CITY OF NOVI CITY COUNCIL
SEPTEMBER 28, 2020

SUBJECT: Consideration of Zoning Ordinance Text Amendment 18.293 to amend Article 5.0, Site Standards, Article 5.5, Landscape Standards, and modifications to the Landscape Design Manual, in order to update and revise the landscaping plantings and buffering requirements of the Zoning Ordinance, and other items deemed necessary. **FIRST READING.**

SUBMITTING DEPARTMENT: Community Development, Planning

Figure 5.5.3.B.ii.Footnote 10

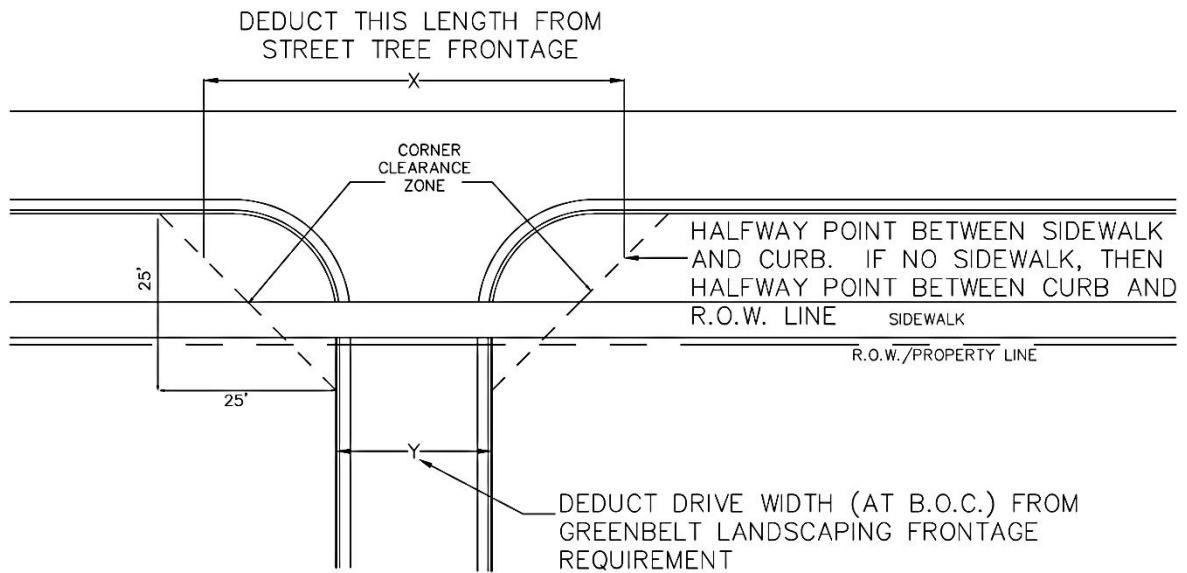
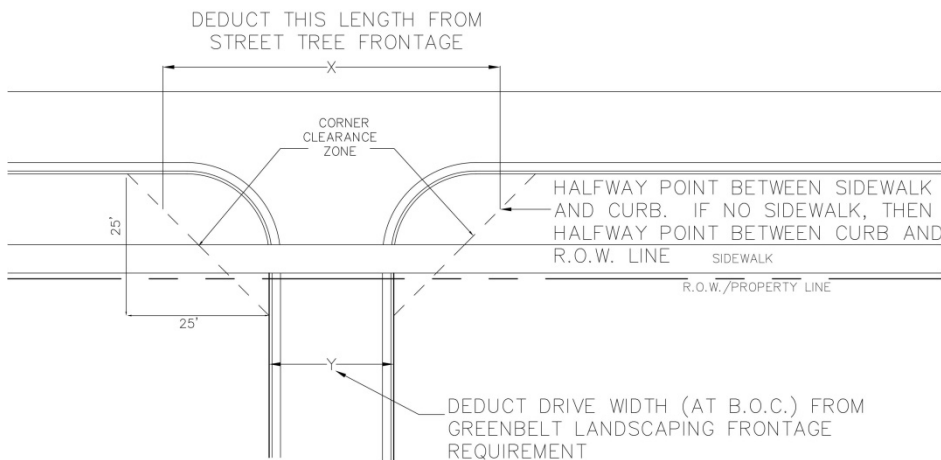
- ~~(21) Linear deductions allowed for street trees and right-of-way greenbelt landscaping:~~

(22)(11) In the Town Center districts, deciduous canopy/large evergreen trees or subcanopy trees are required in the greenbelt, but not both. One or the other requirement shall be met, not a reduced combination of both types.

Figure 5.5.3.C.iii

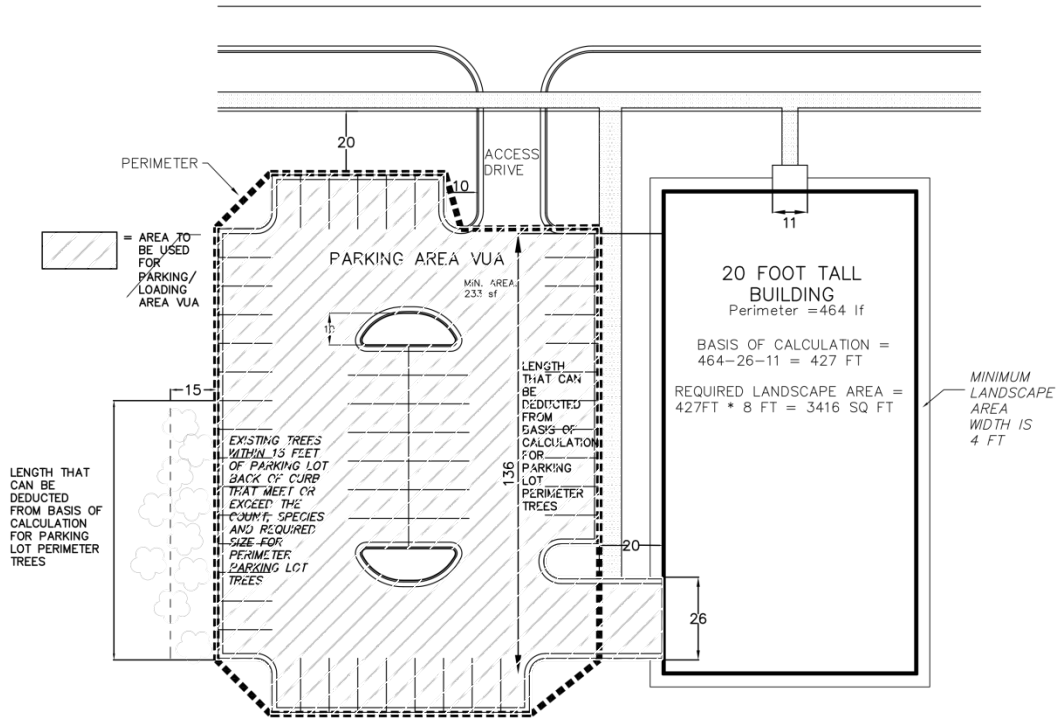
~~(2)(1) Vehicular Use Area (VUA) to be used in this calculation includes parking spaces, loading/unloading areas and access aisles within the parking lot. It does not include drives to the Vehicular Use Area or long drives without parking spaces between parking areas adjacent. (See Figure 5.5.3.C.iii (2) See illustration below.~~

~~(3) The landscaping for the total requirement should be spread evenly across the entire VUA~~

As an example, a 65,000 square foot parking area in Category 1 would require 50,000 x 7.5% plus 15,000 x 1% = 3750sf + 150 sf = 3900 sf landscape area within the parking lot boundary. ~~Loading/Unloading areas also count toward vehicular use area.~~
have

g. Figure 5.5.3.C.iv

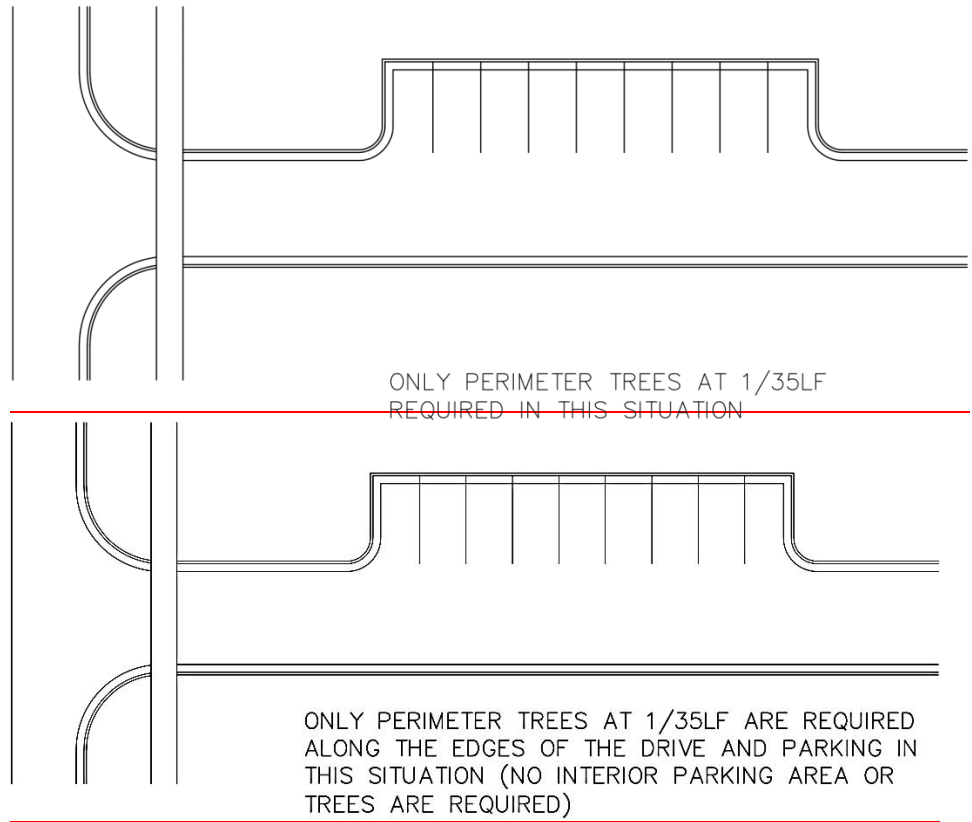
i. If a parking bay abuts a drive but no other parking, only perimeter trees along the drive and parking are required (no interior parking). See illustration below:

j. Perimeter canopy trees are also required along access drives with no parking such as, but not limited to, along a building or between parking areas at a rate of 1 tree per 35lf on both sides of the road unless buildings or natural features make such plantings not feasible or undesirable.

Figure 5.5.3.D.

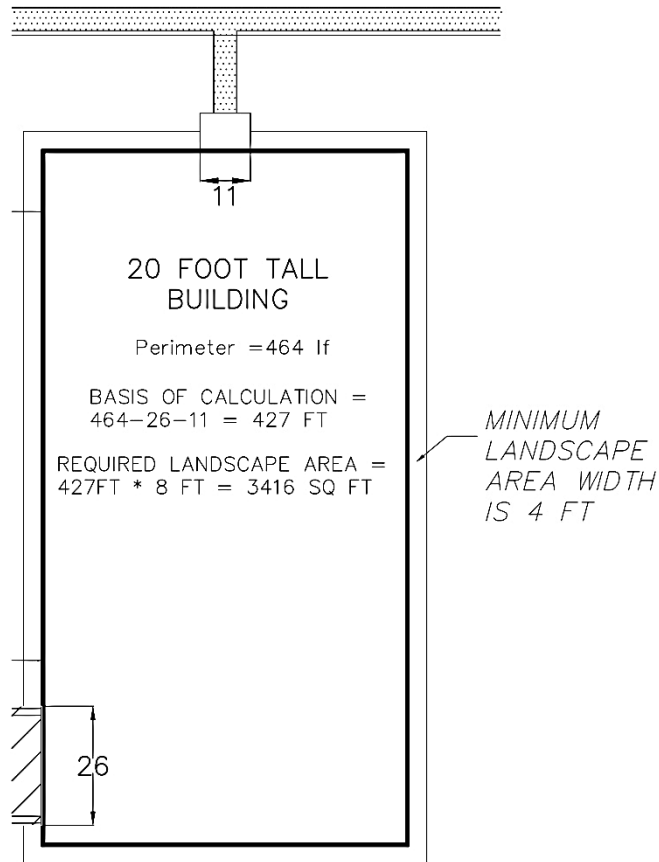
- ii. Requirements. For all buildings or accessory buildings requiring site plan review, the following shall apply:
 - a. There shall be, as a minimum, interior site landscaping square footage equal to the quantity calculated by multiplying the entire perimeter of the building, less the paved access points including walkways to the building (but not including those walkways or drives immediately along the building) and vehicular entrance ways to the building interior (i.e. garage doors) by eight feet. See the ~~diagram below~~^[BL1].

- b. Landscaped planting beds shall be placed immediately adjacent to the building ~~on for as much of the building as possible, with at least a minimum of~~ 75% of the building foundation having landscaping. Landscape beds must have a ~~and have a~~ minimum width measuring dimension of four feet from the building. ~~Lawn areas shall not be considered toward the required greenspace.~~ Creativity of the physical configuration of the landscape planting bed shape and dimension is strongly encouraged. Applicant is encouraged to provide additional greenspace adjacent to the building wherever possible.

c. All foundation landscaping areas shall be labeled in square feet ~~such~~ on the landscape plan, ~~with the area in square feet of that area.~~ Lawn areas shall not be considered towards part of the required greenspace.
